**TITLE:** PUBLIC HEARING regarding a Subdivision Permit and Plat for Riatta Flats Subdivision, located on Lot 1, Aspen Hills Subdivision, 1<sup>st</sup> Filing, Laramie County, WY.

**RIATTA FLATS  
PRELIMINARY  
DEVELOPMENT PLAN  
PZ-24-00003  
&  
SUBDIVISION PERMIT & PLAT  
PZ-24-00004**

# Applicant Response Agency Review #1

**RIATTA FLATS**

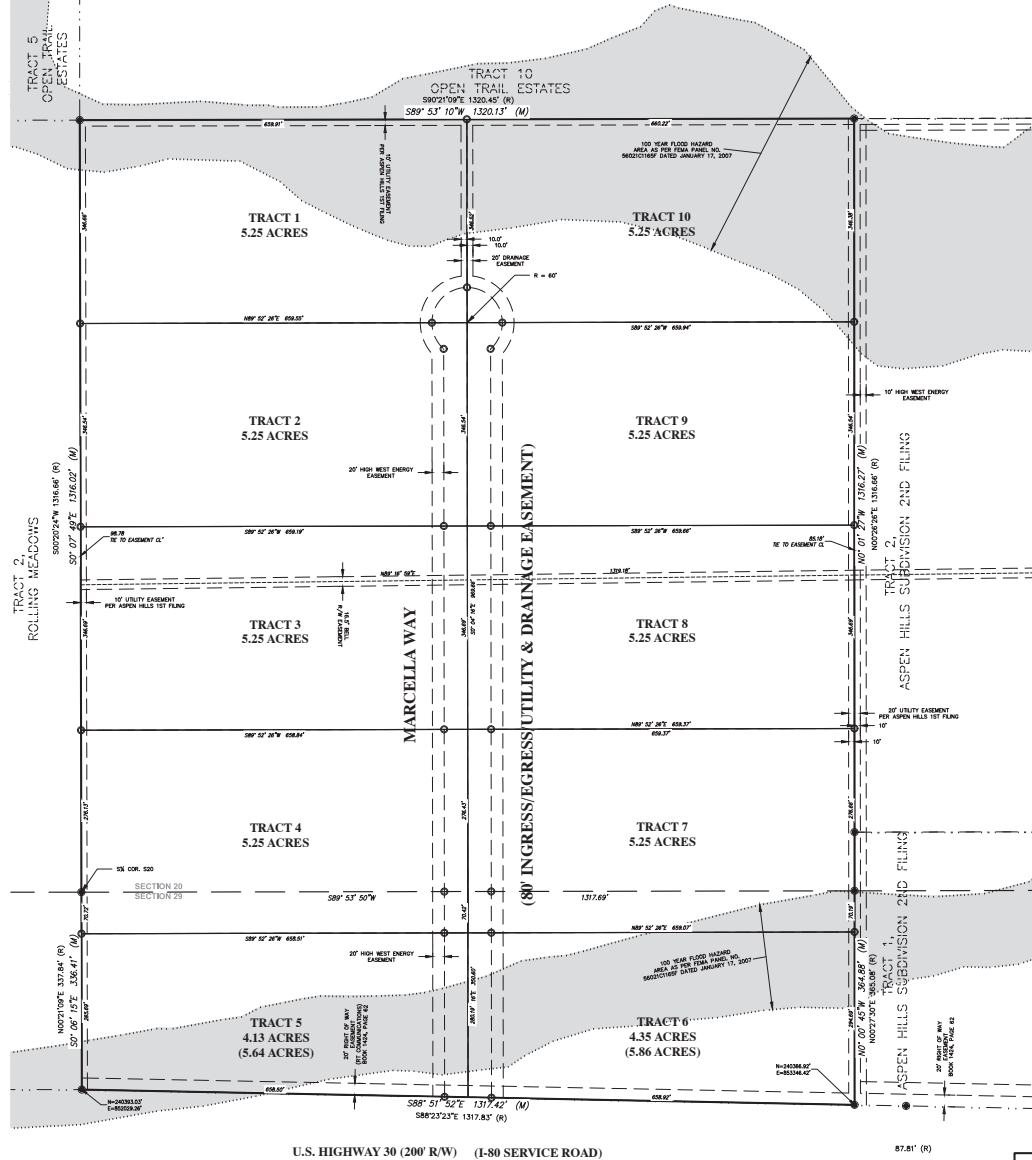
01/24/2024	Workflow	COUNTY REAL ESTATE OFFICE REVIEW	GENERAL	NO comments	LAURA.PATE@LARAMIECOUNTY WY.GOV
01/26/2024	Application	PZ-24-00004	GENERAL	<p>Engineer Review</p> <ol style="list-style-type: none"> <li>1.A Floodplain Development Permit application shall be submitted for the roadway that crosses the floodplain.</li> <li>2.I concur with the request for a waiver of a detailed Drainage Study and Traffic Study since this development will have negligible impact on both.</li> <li>3.The site location shown on the vicinity map is incorrect. It shows this site as being adjacent to CR 144, but it is further to the west of CR 144.</li> <li>4.It is strongly suggested/recommended that the 80 Ingress/Egress easement be dedicated right-of-way.</li> <li>5.Designs for Marcella Way shall meet the LCLUR regulations and be submitted to the County for review and approval.</li> <li>6.Access off Highway 30 shall comply with WYDOT requirements.</li> <li>7.It seems there may be a need for a drainage easement at the end of the cul-de-sac to take the drainage from the roadside ditches across Tracts 1 and 2 and into the floodplain area that needs to be included on the plat.</li> </ol>	SCOTT.LARSON@LARAMIECOUNTY WY.GOV

1. Boundary ties from the intersection of the TRACT boundary lines to the right-of-way boundary of MARCELLA WAY (to be monumented as shown on the plat) should be provided at the cul-de-sac at the north end and at the south end of MARCELLA WAY along U.S. HIGHWAY 30.
2. Who or what utility is served by 20 RIGHT OF WAY EASEMENT (BOOK 1424, PAGE 62), located along the south boundary of the subdivision?

01/29/2024	Application	PZ-24-00004	GENERAL	Wastewater permits are required for each lot. All small wastewater systems must have a 50' setback from all property lines and intermittent bodies of water i.e. drainages and floodplains. Keep wastewater systems out of easements. A DEQ letter and Chapter 23 report must be submitted to this office along with signed final plat prior to application for any permits.	KIMBERLY.BURGES@LARAMIECOUNTY.WY.GOV
				acknowledged	
01/29/2024	Workflow	ENGINEERS REVIEW	GENERAL	.	MOLLY.BENNETT@LARAMIECOUNTY.WY.GOV
01/29/2024	Workflow	PUBLIC WORKS REVIEW	GENERAL	<ol style="list-style-type: none"> <li>1. All comments provided on the PDP (PZ-24-0003) shall be address within this subdivision permit and plat.</li> <li>2. General Note F - "FROM" is misspelled</li> <li>3. I concur with the comments from the review engineer, WYDOT, et al, please address accordingly.</li> <li>4. Any work taking place within the boundaries of the designated floodplain and/or floodway will require an approved Floodplain Development Permit through the Laramie County Planning and Development office.</li> <li>5. Access for this lot is off of a road under the jurisdiction of WYDOT. Any access changes shall be coordinated through WYDOT.</li> </ol>	COURTNEY.LUHRSEN@LARAMIECOUNTY.WY.GOV

see pdp responses

boundary ties are already shown.  
telephone easement

note - all corrections will be shown on final plat only.
